#### ADDENDUM NO. 1

A New Branch Bank for First Community Bank 202 Greenwood Avenue – Hwy. 135 & Holmes Street Lepanto , AR

Project #1733

March 10, 2023

FLOOR FINISH PLAN

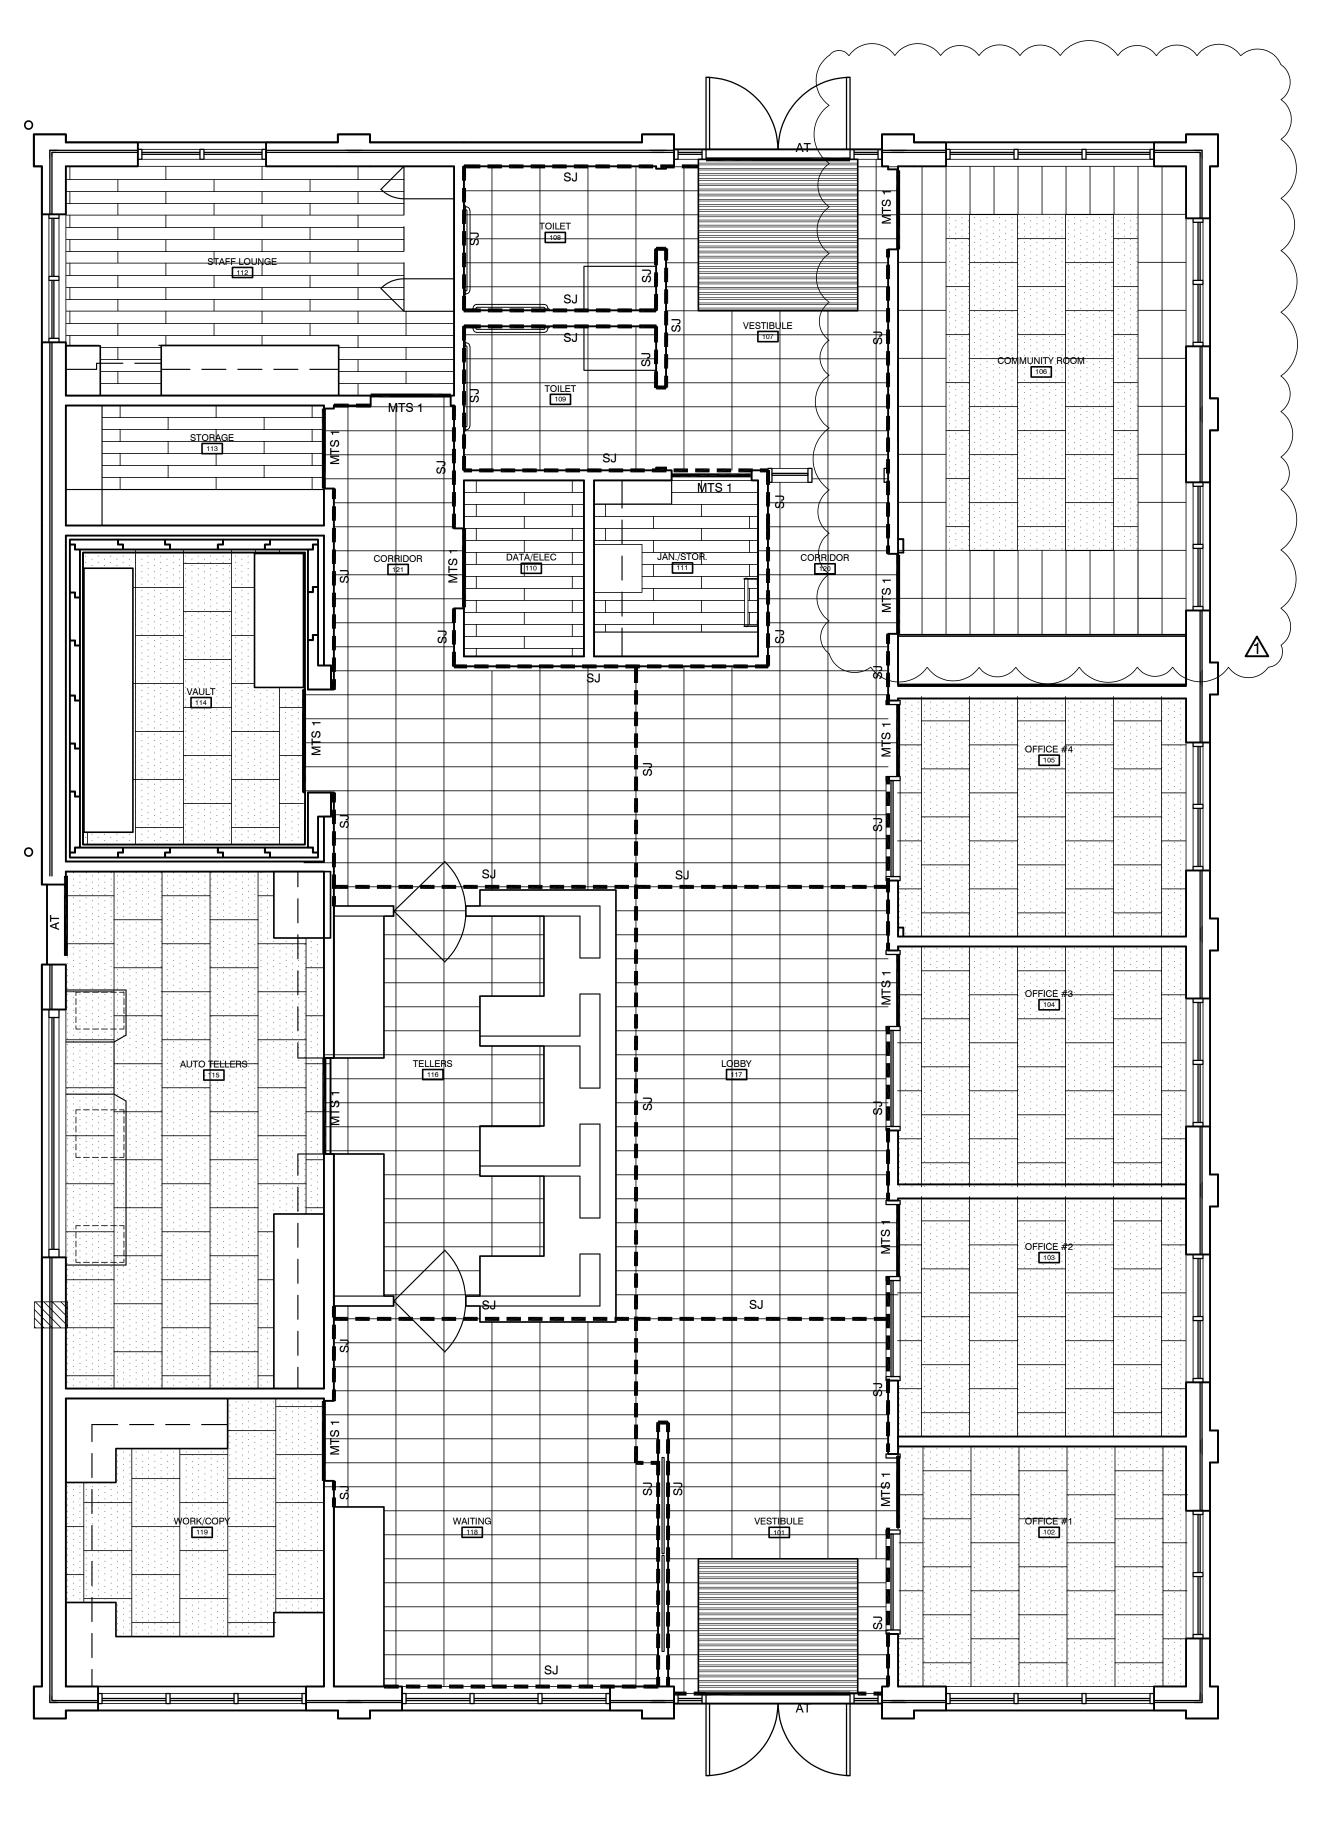
- C. Add a surface mounted sanitary napkin disposal unit in Toilet 108. Location to be determined by the Architect.
- D. Add a tile border in the Conference Room refer to attached reissued Sheet A9.1.

**ELECTRICAL** SITE PLAN

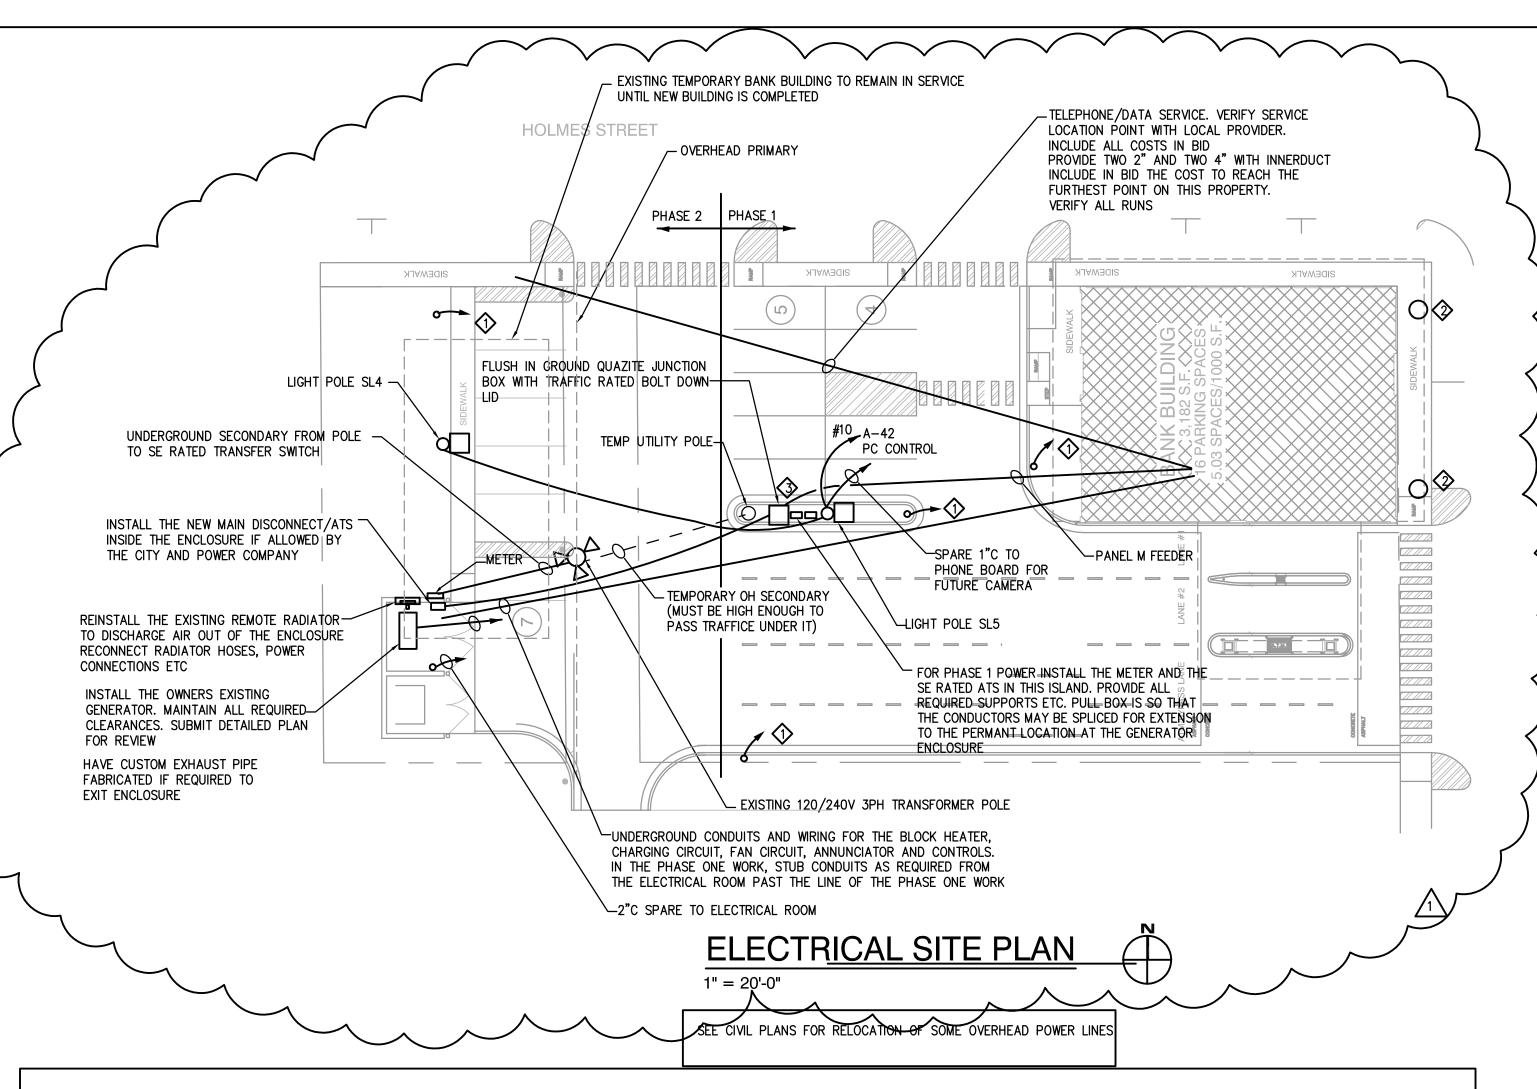
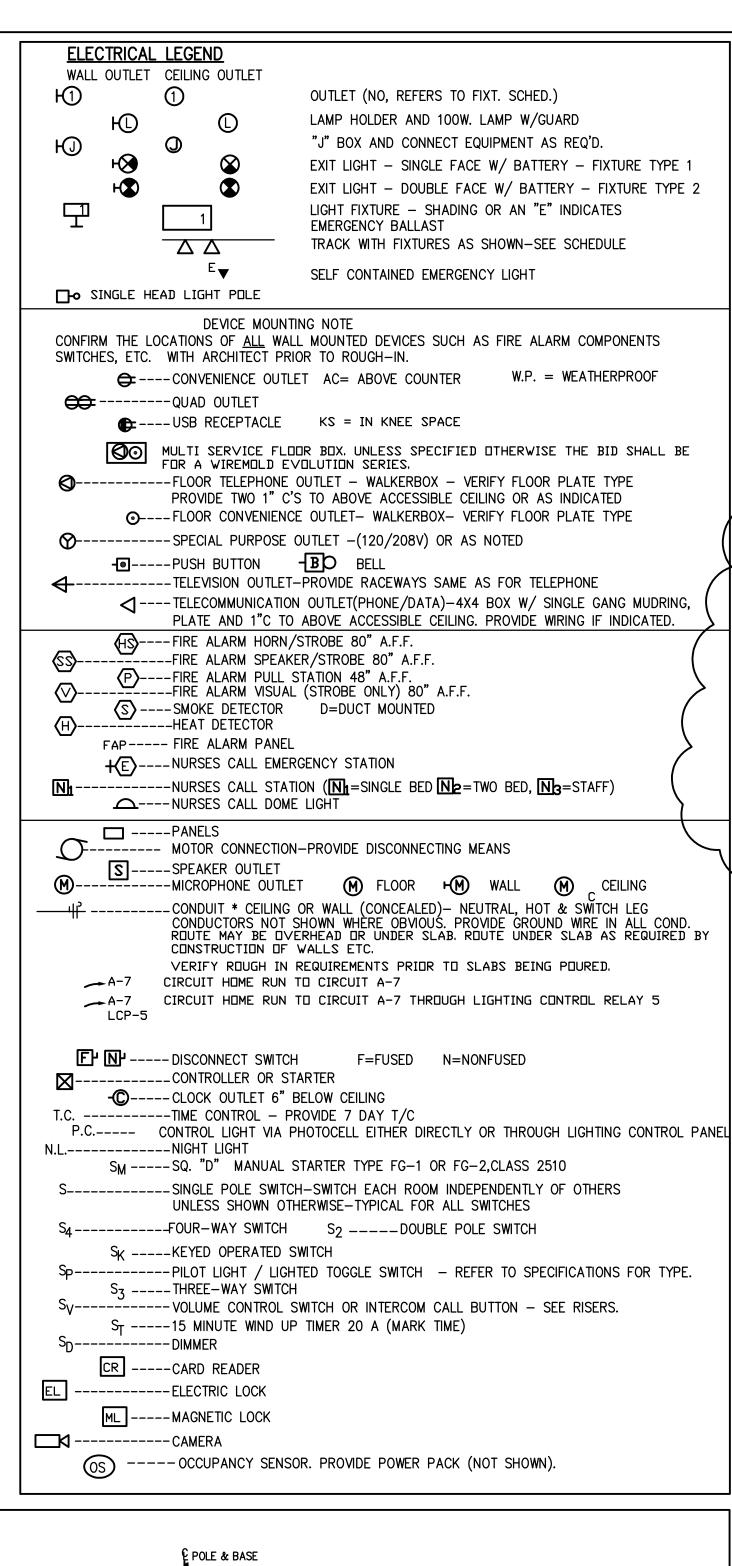
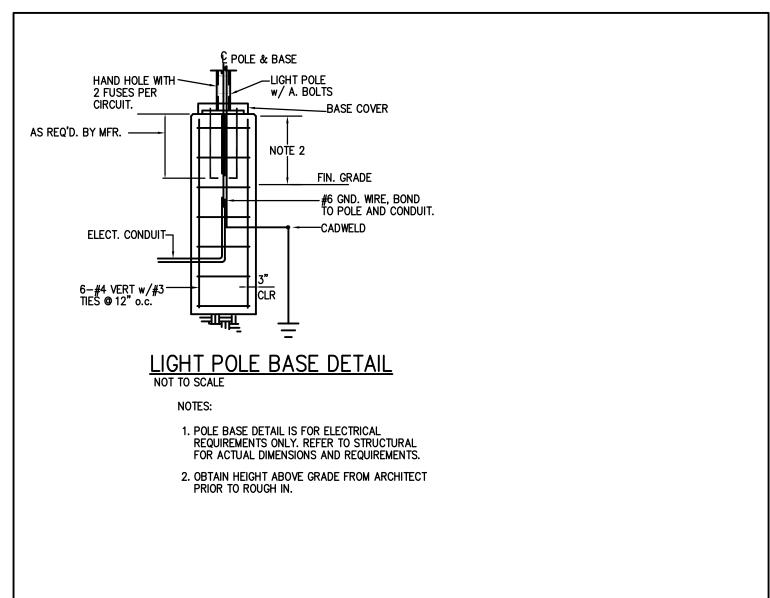
- B. This addendum includes the necessary work to provide temporary power to the new building while keeping the existing portable bank building operational. The work includes a temporary installation of electrical service equipment. After the new building is completed the portable bank building will be removed, generator enclosure constructed and then the service equipment relocated to the permanent location at the generator enclosure. The outage time for conversion from temporary to permanent is limited to the owners banking schedule. Include weekend work as necessary. Include a \$5000 allowance for possible Entergy charges related to the temporary and permanent service work. Refer also to attached reissued Sheets E1.1 and E4.1.

PROVIDE FOR A TEMPORARY LOCATION OF THE SERVICE ENTRANCE TRANSFER SWITCH AND METER AT THE ISLAND AS SHOWN PROVIDE A FLUSH IN GROUND PULL BOX (SIZED PER CODE) FOR THE CONNECTIONS, IN PHASE TWO, THE TRANSFER SWITCH AND METER ARE TO BE RELOCATED TO THE GENERATOR ENCLOSURE WHERE THEY ARE SHOWN ON THE PLANS. THE CONTRACTOR WILL EXTEND THE REQUIRED CONDUITS TO THE PERMANENT LOCATION. AT THAT TIME PROVIDE NEW CONDUCTORS FROM THE ATS TO THE PULL BOX AND SPLICE WITH POLARIS WATERPROOF, SPLICES.
